PLANNING AND ZONING BOARD STAFF REPORT

102 SE 5th Avenue

Meeting	File No.	Application Type
March 17, 2025	2024-170	Level 3 Site Plan
Property Owner	Authorized Agent	
4TRO Propco LLC	Jeffrey A. Costello, JC Planning Solutions

Consideration of a Level 3 Site Plan Application with Architectural Elevations and Landscape Plan for a four-story, approximately 35,000 square foot, eight-unit multi-family residential development.

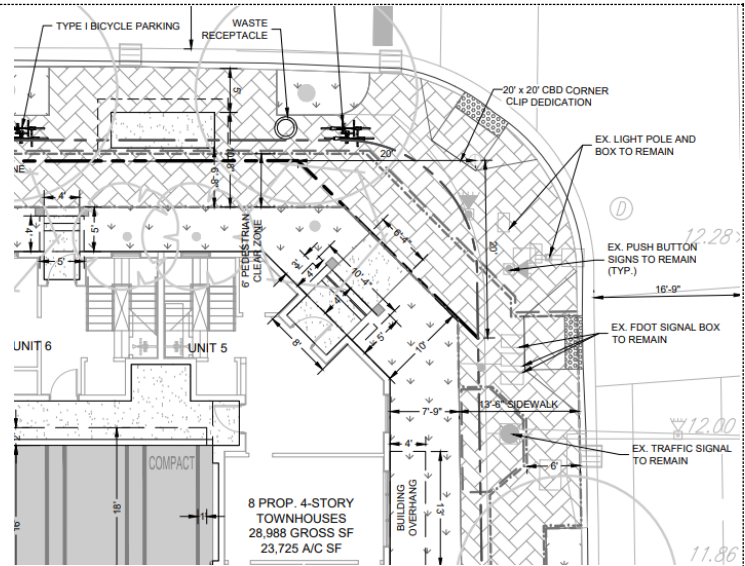
The minimum streetscape dimensions are provided in a way that maintains the maximum feasible pedestrian clear zone, while still allocating sufficient area for foundation landscaping and curb zone landscaping, which helps soften the starkness of the urban environment, and provides buffered protection between the pedestrian and vehicle travel lanes. The applicant and staff have worked closely to ensure that the amount of sidewalk area devoted to pedestrians is substantial enough that the landscaping does not have an unintended consequence of creating a constricted bottleneck or pinch point along a heavily trafficked sidewalk.

The clear zone has been routed to ensure that existing above ground traffic infrastructure does not obstruct the pedestrian path, and likewise, a new covered bus shelter has been located to ensure that the pedestrian clear zone is not reduced below minimums. The provision of the bus shelter, expansion of the sidewalk, and introduction of a shaded tree canopy are substantial amenity improvements within the public realm that will benefit the general public.

(Adjacent properties as viewed south from the alley)

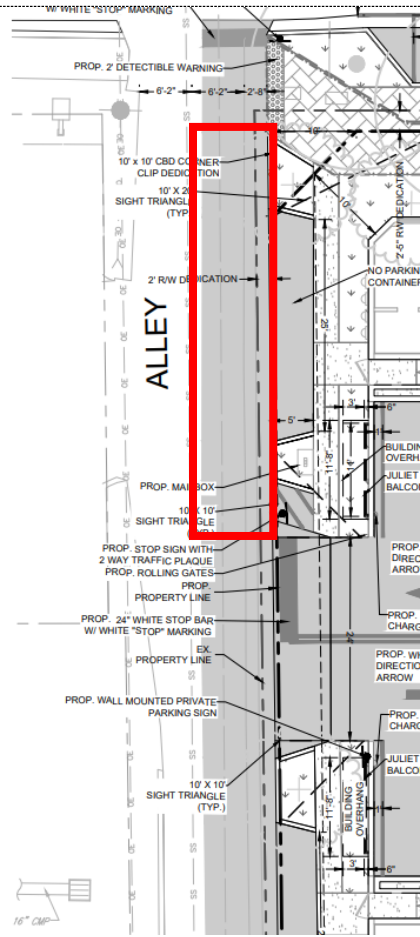
This development proposal does not include any dedicated loading zone. The loading requirement likely anticipates that a 35,000 square foot development would have a significantly higher unit count than eight (with a higher unit count generating more significant loading demand); the large individual unit sizes on small infill luxury residential developments that have become common in Delray were not contemplated when the regulation was adopted. However, the proposed number of units, while not significant, will at some point require use of a loading zone, and because one is not provided conflict with the surrounding area is anticipated.

While the applicant has stated in their explanation of loading demand that daily freight and parcel delivery from smaller vehicles will be handled in an area provided off of the alley, which is provided within this development for the primary purpose of staging for trash pick-up, the provided area is not large enough to qualify as a loading zone, and further, is not large enough to reasonably accommodate large delivery and moving trucks. As such, it can be expected that during periods of move-in/move-out and delivery of large furniture and appliances, vehicles will at least partially obstruct the alley for significant periods of time. This may negatively impact the open flow of the street and alley network and negatively affect surrounding properties. It is important to note that the two properties directly west of the subject property have the only access to their parking area off of the alley (images next page). Large delivery vehicles servicing the property at 102 SE 5th Ave could conflict with or outright prevent vehicle access to the adjacent properties. The Board shall consider whether this is something that should be corrected or whether this is an unavoidable consequence of dense and compact downtown development on small parcels and, as such, the request is acceptable.

Garage Circulation

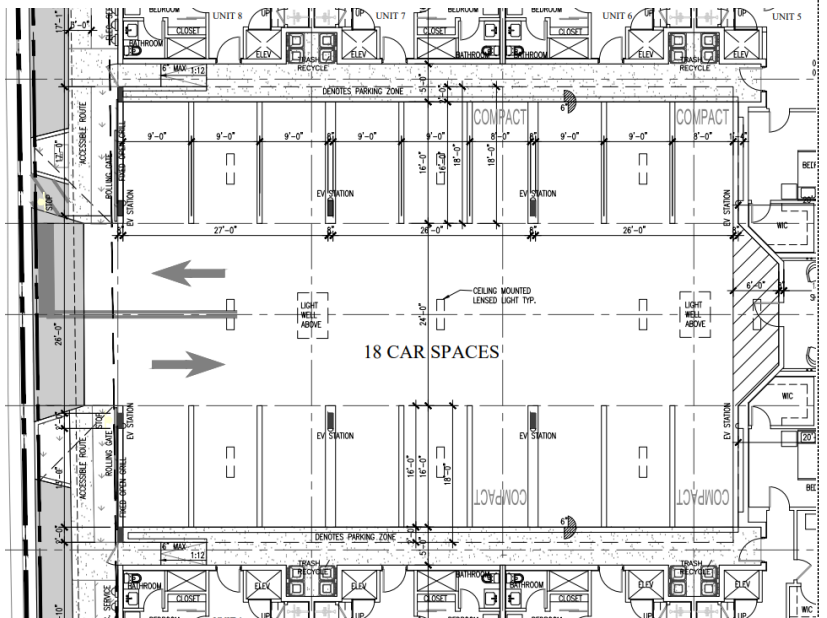
The 8-unit development has a parking requirement of 18 spaces. The development provides 18 spaces in the ground floor garage as well as two via new on-street spaces for a total of 20 spaces, which is a surplus of two. The parking garage is configured with 9 spaces on each side of the drive-aisle. It is an extremely tight configuration with the interior entrances to the units only separated from the parking stalls by a 3-foot-wide walkway.

While the 3 feet provides the absolute minimum functionally required to be able to navigate trash bins from the unit storage to the exterior staging area, and while it provides the minimum necessary to allow for an unencumbered pedestrian to walk from a parked vehicle to a unit entrance, the tight configuration provides no functional room for residents to be able to successfully maneuver larger objects (i.e. furniture, appliances, packages) from their vehicles to their units, especially in scenarios where all 18 parking stalls are occupied.

Given there is a surplus of two spaces, staff strongly encourages that two spaces (one on each side) are removed and replaced with a landing area that will allow for residents to more feasibly navigate from their parked vehicles to their unit entrance when encumbered with larger objects. As configured, the access to the units is unnecessarily compromised. The trade-off of exchanging two surplus spaces for better functionality and maneuverability within the garage is a net positive in the opinion of staff. The Board should consider whether the

proposed garage configuration is acceptable with the identified spatial constraints, or if the applicant should revise the request pursuant to the staff recommendation.

EAST FACADE

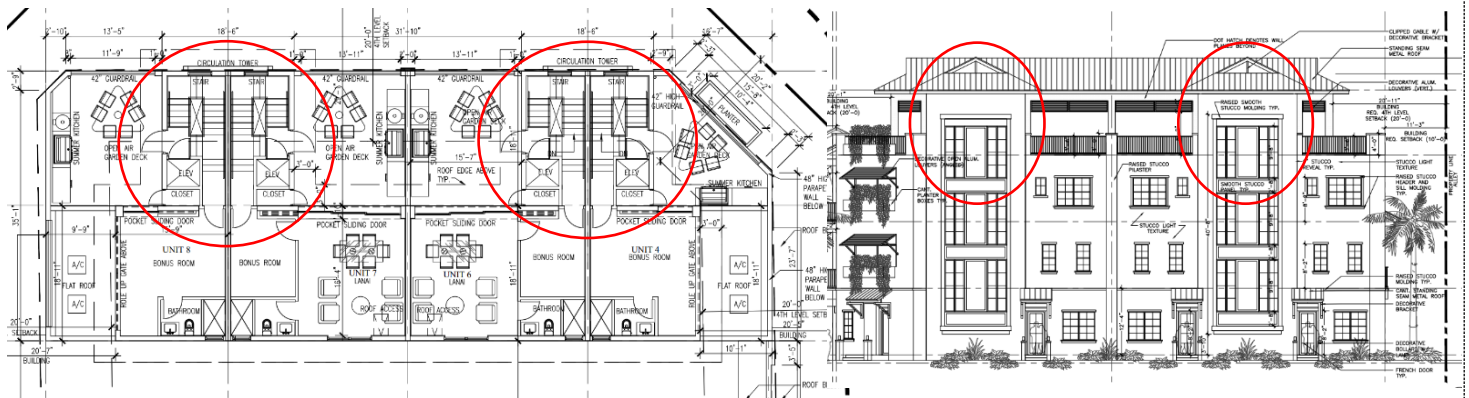
The aesthetic standards of this Section have been met by the proposed architectural design. The architectural style of Anglo-Caribbean is a permitted design in the CBD, is regionally appropriate, and is a customary style for coastal Florida architecture. The composition is a well-executed version of the style, introducing movement and interest across the facades through articulation, changes in height, and subtle and stylistically appropriate ornamentation, including bracketed balconies, wood accents, stucco molding, and decorative louvers.

The composition maintains compliance with established façade proportion ratios that allow the building to maintain consistency with the historic downtown scale, and the design successfully incorporates a tripartite composition where a clear base, middle, and top of the composition is defined, which is an important aspect of traditional architectural style and something the CBD guidelines strongly require.
